**Addendum No. 4
October 27, 2023**

Project: **Harrisburg South Middle School Theatre Addition**
Harrisburg, South Dakota
Architecture Incorporated Project #3024

DOOR DETAILS

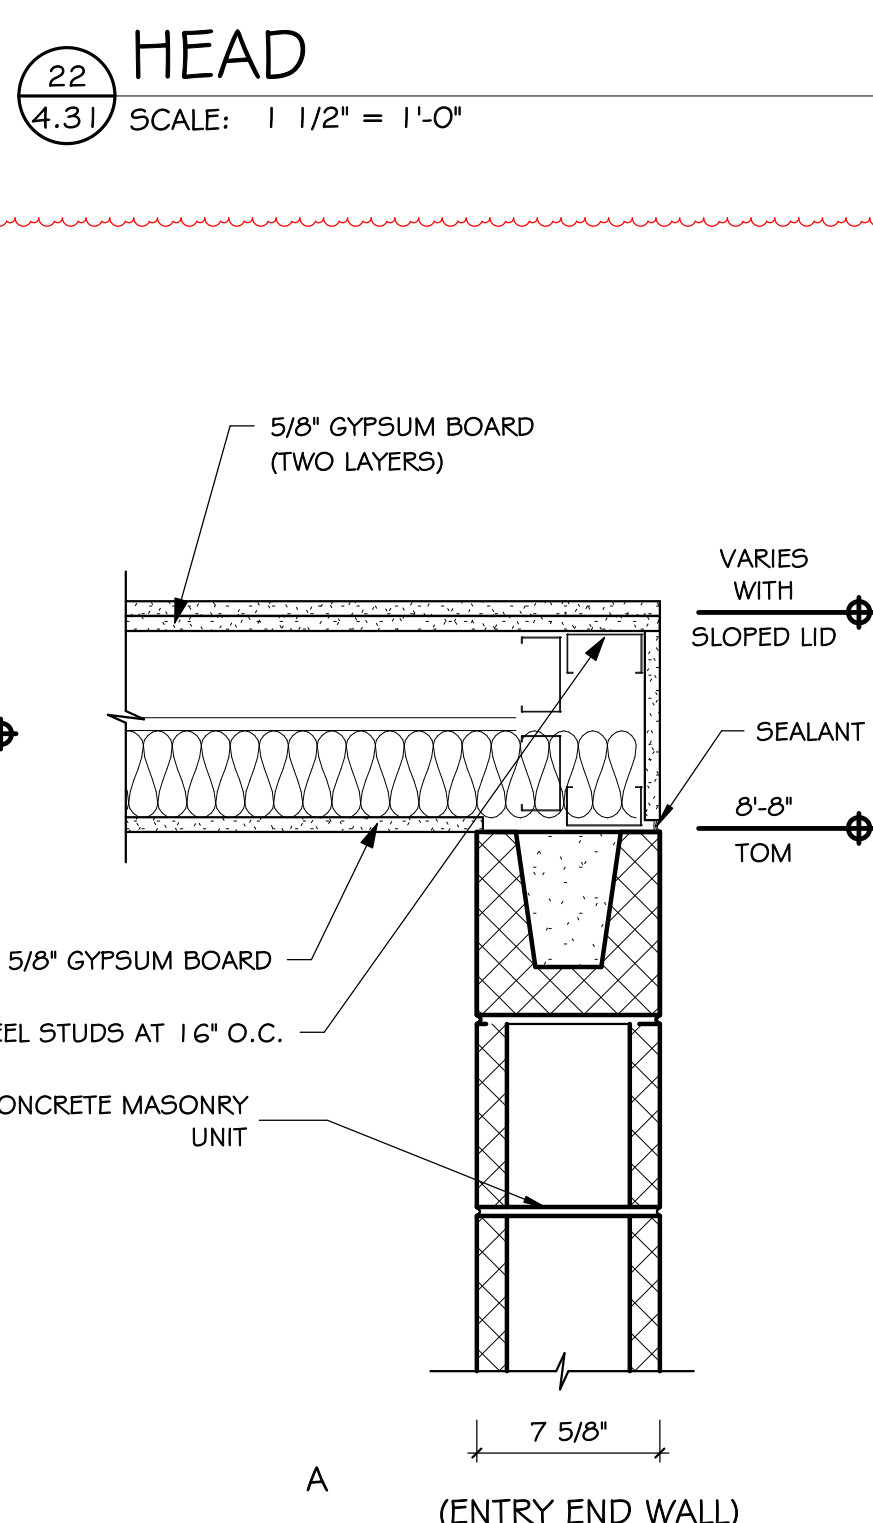
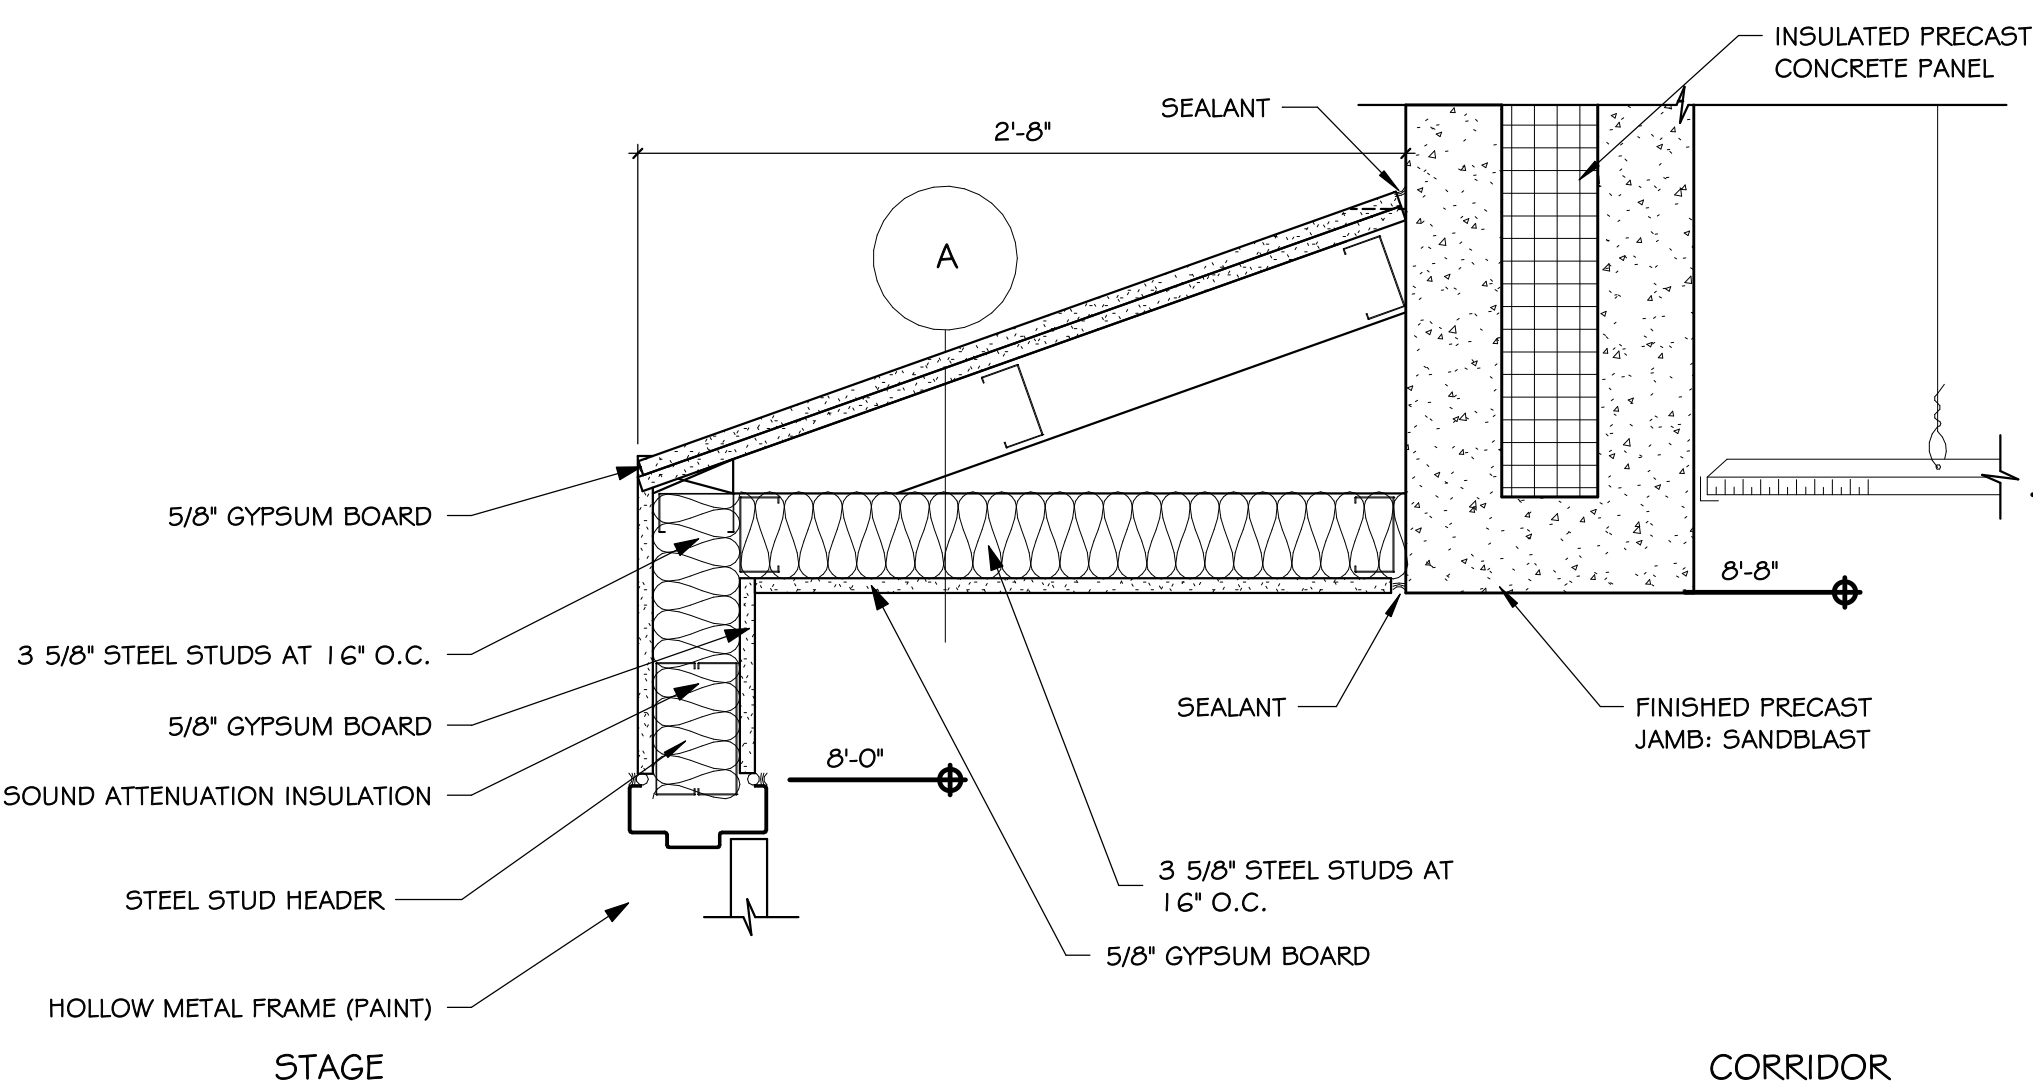
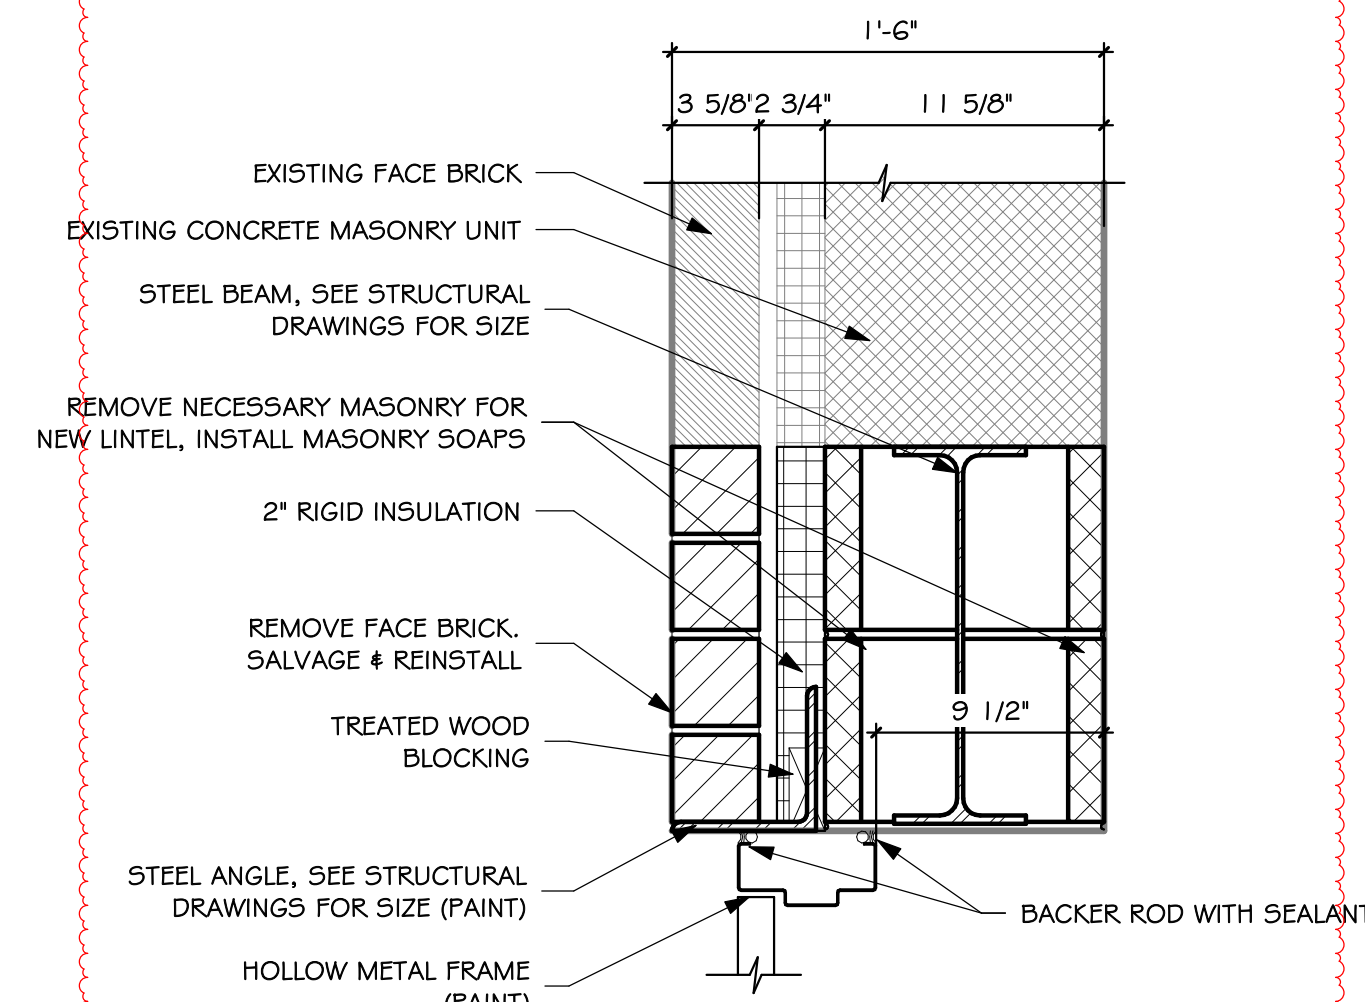
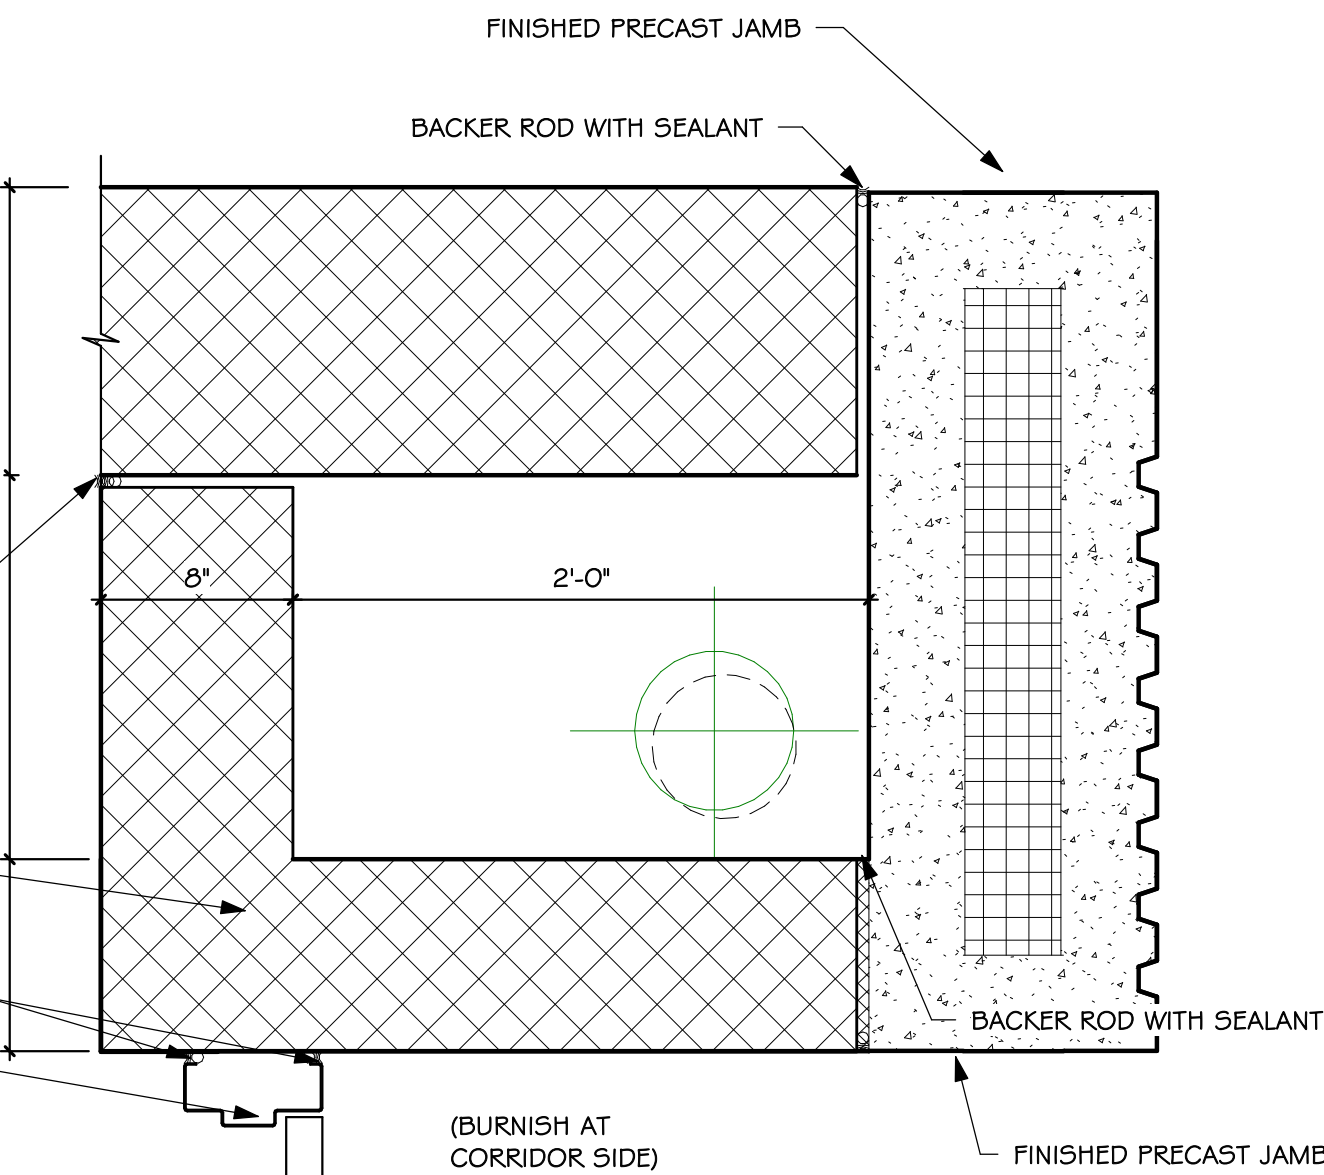
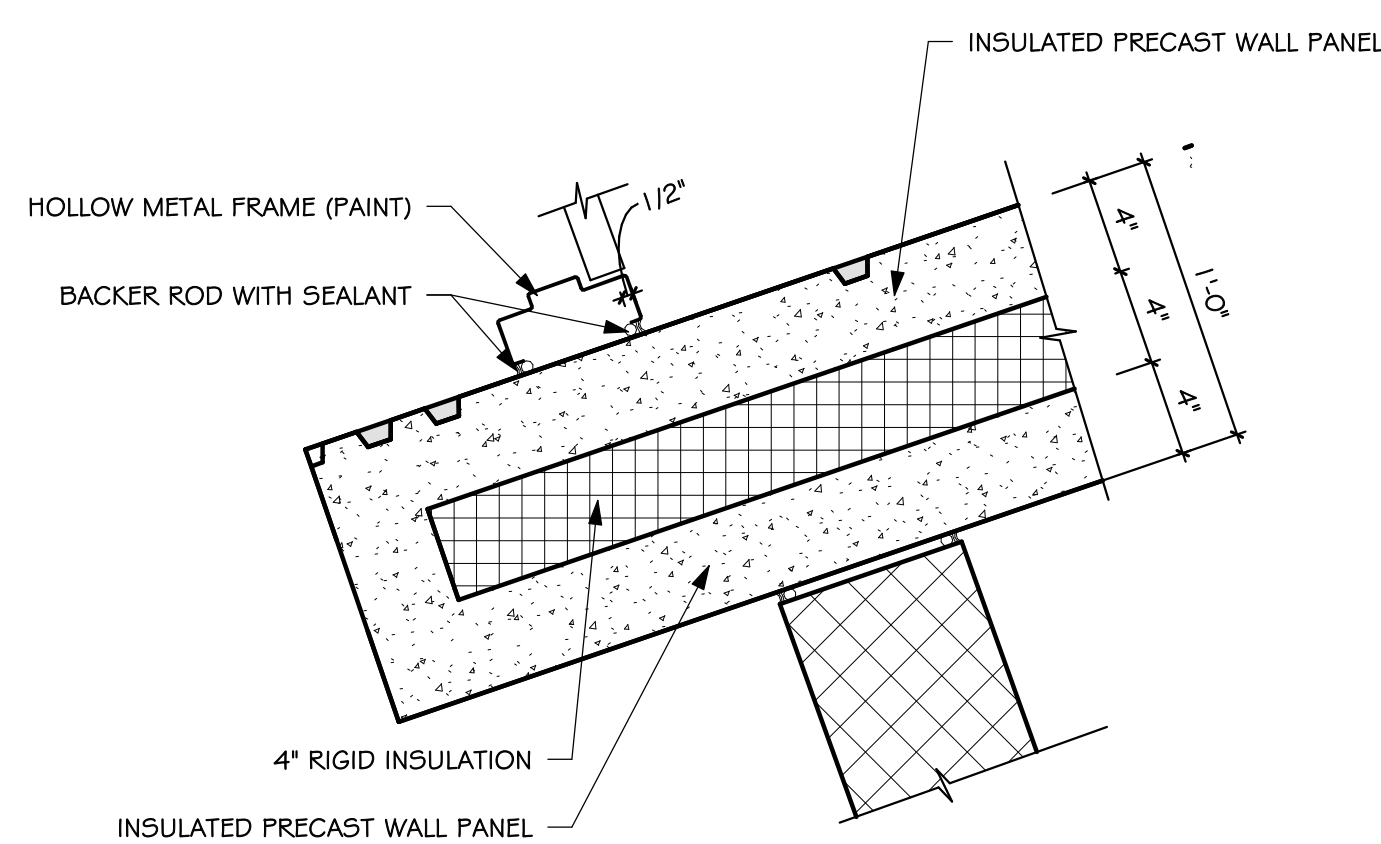
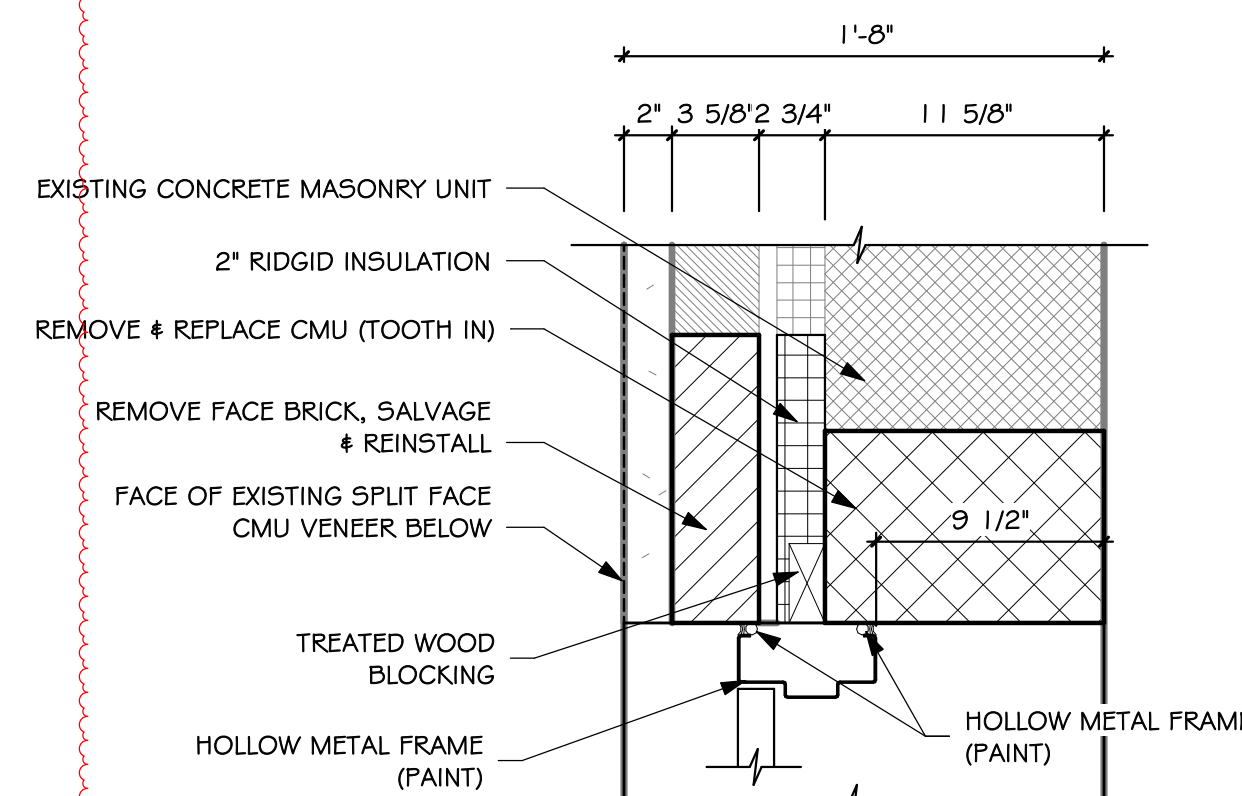
- a) Reference the BORROWED LITE TYPES SCHEDULE on *revised* drawing Sheet 4.31, with revision date of 10-26-23, attached to the end of this addendum, for newly added head, jamb, and sill detail references for borrowed lite types (MARK); 1, 2 and 3.

- b) Reference the BORROWED LITE TYPES SCHEDULE on *revised* drawing Sheet 4.31, with revision date of 10-26-23, attached to the end of this addendum; add a vertical mullion at borrowed lite type '3' as shown (two equal spaces).

- c) Reference *revised* drawing Sheet 4.31, with revision date of 10-26-23, attached to the end of this addendum, for revised details. **HEAD - 15/4.31, JAMB - 16/4.31.**

- d) Reference *revised* drawing Sheet 4.31, with revision date of 10-26-23, attached to the end of this addendum, for revised details. **HEAD - 19/4.31, JAMB - 20/4.31, SILL – 21/4.31.** (Details omit bent plat at head and jambs and add steel pipe at sill detail).

- e) Reference *revised* drawing Sheet 4.31, with revision date of 10-26-23, attached to the end of this addendum, for newly added detail. **HEAD - 22/4.31.**
